V2500-A5/D5 SERIES PROPULSION SYSTEM SERVICE BULLETIN

This document transmits the Revision 3 of Service Bulletin V2500-ENG-72-0522.

V2500-ENG-72-0522

ENGINE – PROVIDE NEW SECOND STAGE VANE WITH INCREASED COOLING AIR**1. Planning Information****A. Effectivity Data****(1) For Airbus A319**

SECOND STAGE HPT VANE RE-OPERATION
Figure 1 (Sheet 1 of 2)

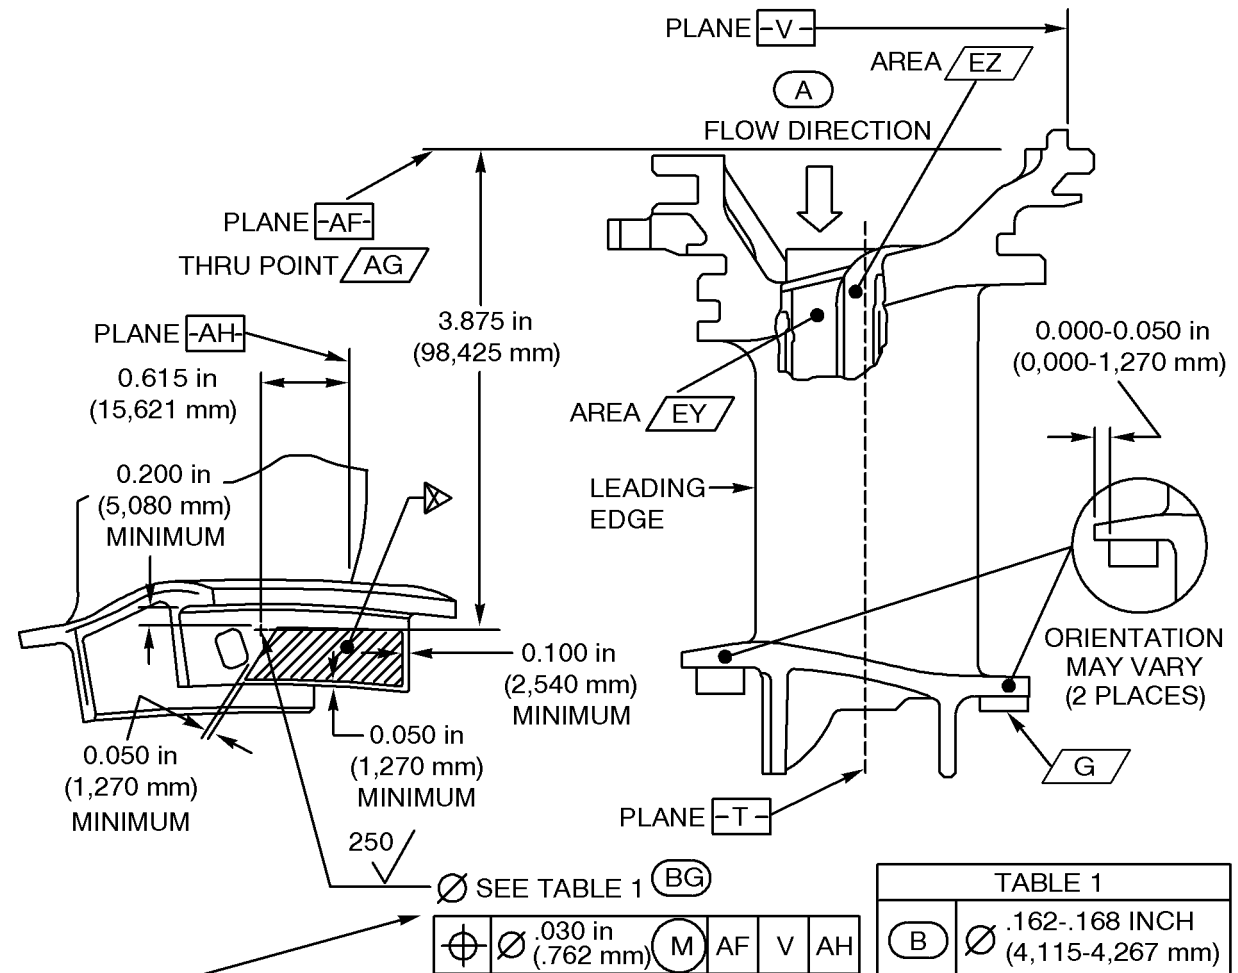
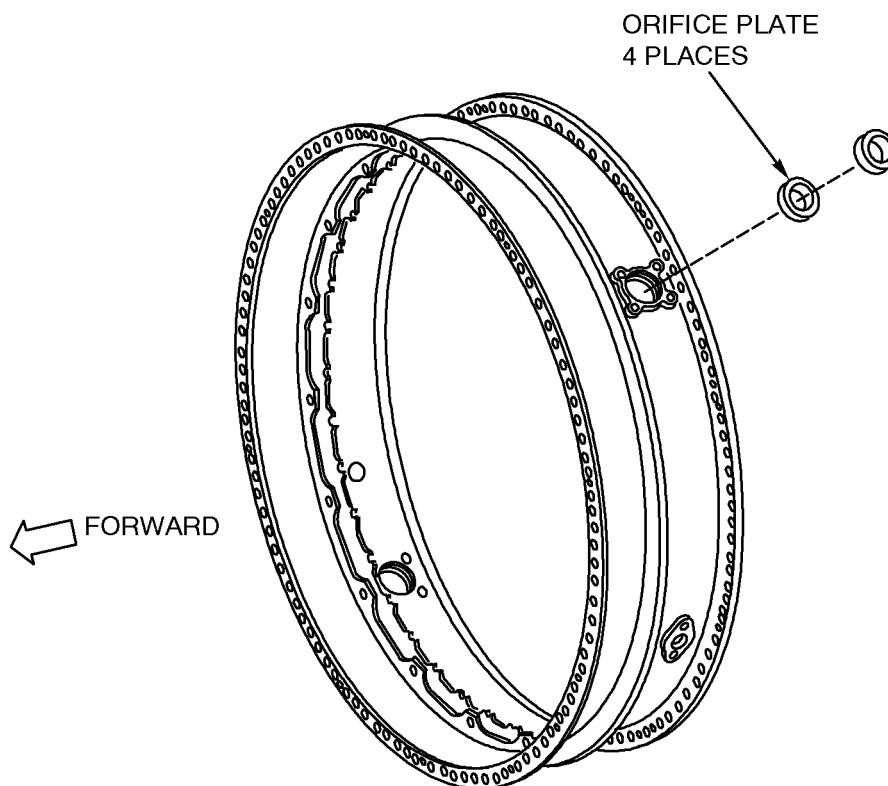
- (i) For Non - Borescope Vanes 2A2052, 2A3352, 2A3832 and 2A2052-001 machine (1) hole 0.162-0.168 (4.115-4.267 mm) diameter. See Figure 1 Sheets 1 and 2. Refer to Table 1 on sheet 2.

- (ii) For Borescope Vanes 2A2152, 2A3452, 2A3842 and 2A2152-001 machine (1) hole 0.162-0.168 (4.115-4.267 mm) diameter. See Figure 1 Sheets 1 and 2. Refer to Table 1 on sheet 2.

- (iii) For Non - Borescope Vanes 2A3402 and 2A3572 machine (1) hole 0.137-0.143 (3.480-3.632 mm) diameter. See Figure 1 Sheets 1 and 2. Refer to Table 1 on sheet 2.

- (iv) For Borescope Vanes 2A3302 and 2A3282 machine (1) hole 0.137–0.143 (3.480–3.632 mm) diameter. See Figure 1 Sheets 1 and 2. Refer to Table 1 on sheet 2.

- (b) Replace front and rear Inner Diameter Platform honeycombs as shown in Figure 1, Sheet 1. Use the engine manual repair 006 VRS3223 task 72-45-24-300-006 with the dimensions shown in Figure 1.

NOTE: THE HOLE MUST BREAK INTO CAVITY /EY/

1. UOS, BREAK EDGES .030 MAXIMUM
2. ▽ MARK IDENT PER MANUAL VIBRATION PEEN (.006 MAXIMUM DEPTH).
3. SURFACE TEXTURE PER IAE 70-35-09, UOS ALL SURFACES $\sqrt{125}$
4. (A) FLOW TEST PASSAGE /EY/ IN DIRECTION SHOWN WITH AREA /EZ/ AND LEADING EDGE AND SHOWER HEAD (4 ROWS TOTAL) HOLES BLOCKED PER IAE 70-72-01 OR SPEC 322 TO OBTAIN AIRFLOW LEVEL OF:

- (c) Flow test passage per note 4 in Figure 1, Sheet 2. Refer to Tooling Availability for tools required.
- (d) Identify the reoperated vane assemblies in accordance with the Reidentified Parts Section of this Service Bulletin.
- (3) Replace Ring Segment part number 2A3431-01 with 2A1106-01 if pre-trenched honeycomb is present.

ORIFICE PLATE LOCATION
Figure 2

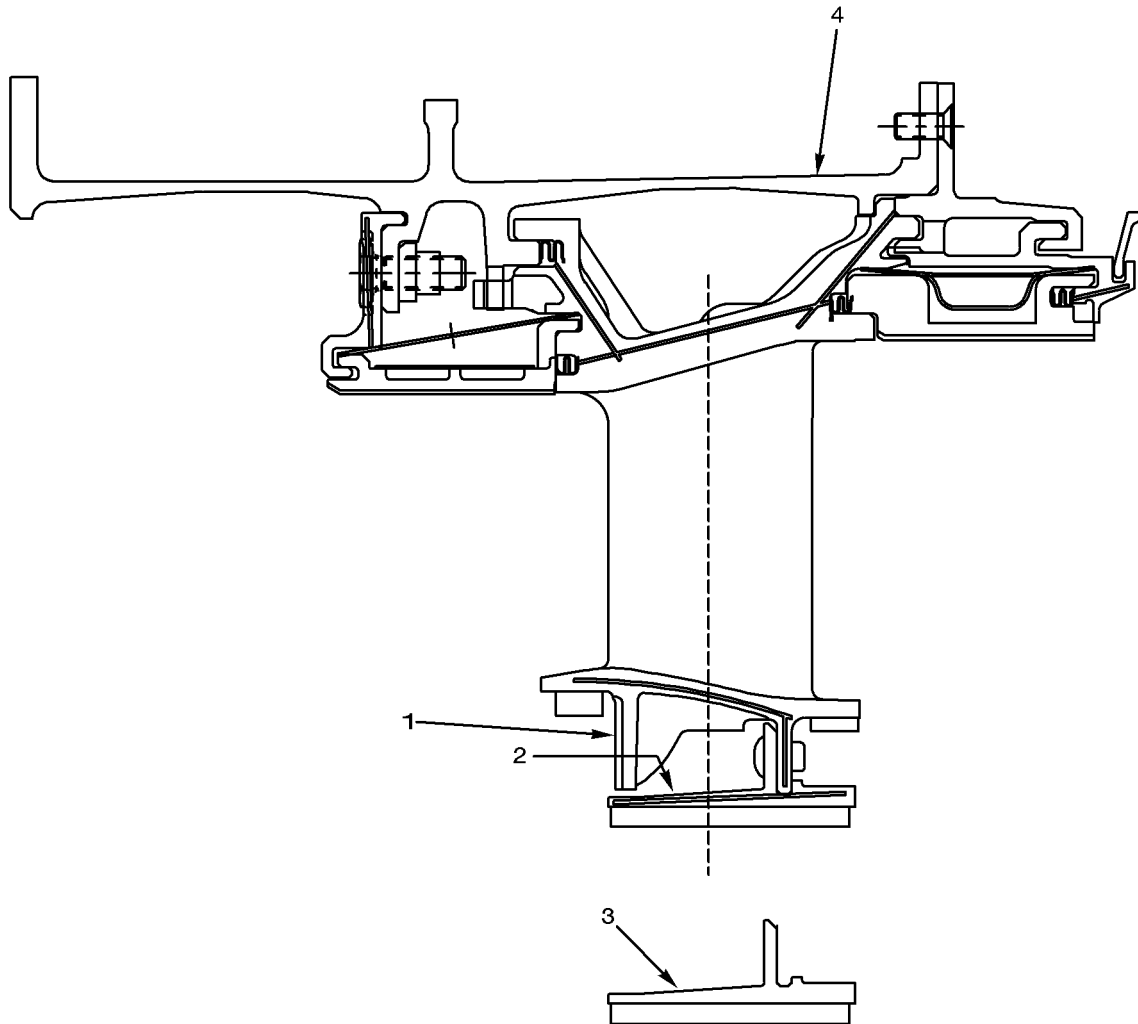
- (b) Replace the Orifice Plate part no. 2A3734 (4 places) with JAEC part number 2A3738. See figure 2 or re-operate as follows:
- (i) Increase the orifice plate diameter as follows:

- (1) Set-up and machine the orifice plate 2A3734 to open the diameter 0.870-0.880 (22.10-22.35 mm) to 0.955-0.965 (24.26-24.51 mm).
- (ii) Hold concentric to the outside diameter 0.010 (0.254 mm).

PART MARKING LOCATION
Figure 3

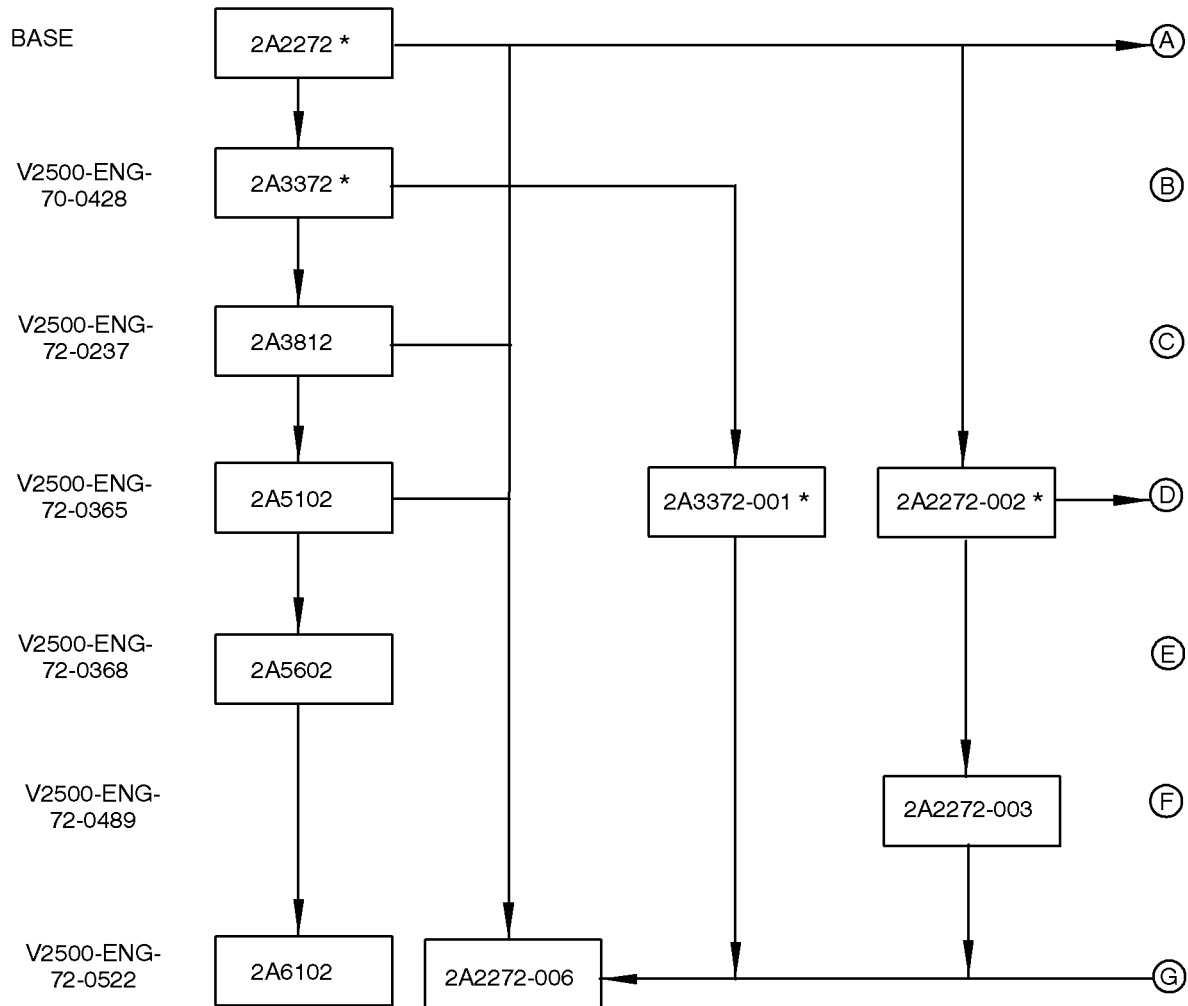
Identify the reoperated Ring Segment Assembly of, Air Sealing 2nd Stage, HPT part number in accordance with the Reidentified Parts Section of this Service Bulletin. Use the vibration peen method specified in reference (15), chapter/section SPP 70-09-00, marking of parts. See Figure 3 for part marking locations.

- R (c) Identify the re-operated Ring Segment and Vane Cluster Assemblies in accordance with the Reidentification Section of this Service Bulletin. Use the vibration peen method specified in reference (15), Chapter/Section SPP 70-09-00, marking of parts. See Figure 3 for part marking locations.

- R (6) Identify the re-operated Case and Vane Assembly in accordance with the reidentification section of this Service Bulletin. Use the vibration peen method specified in reference (15), Chapter/Section SPP 70-09-00, marking of parts. See Figure 3 for part marking locations.
